STAIRWAY SAFETY INSTALLATION

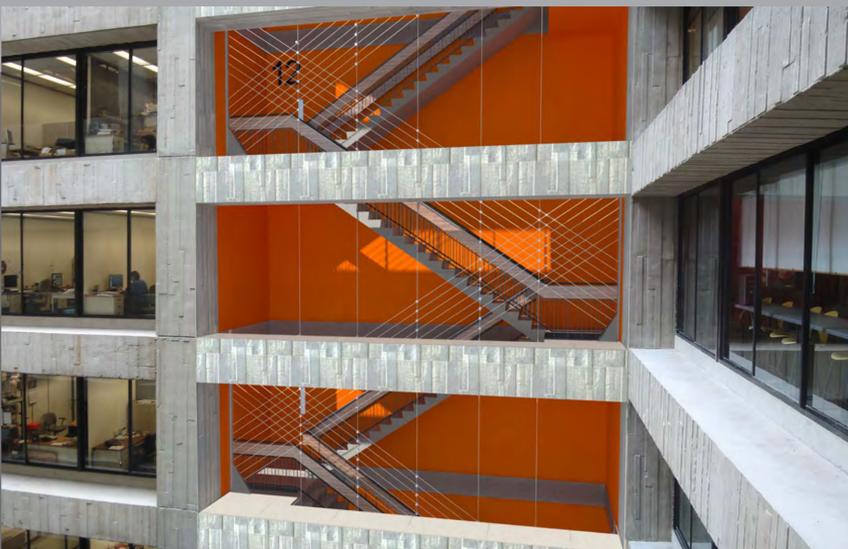
The Atrium East and West stairs will be revised to meet the current code requirements for existing buildings. This will include modifications to the baluster/picket spacing and the installation of graspable rails. Also, additional protection beyond the code requirements will be provided. This will consist of a cable barrier system that will greatly inhibit access from the open stairs at any level to the concrete ledges or into the atrium space.
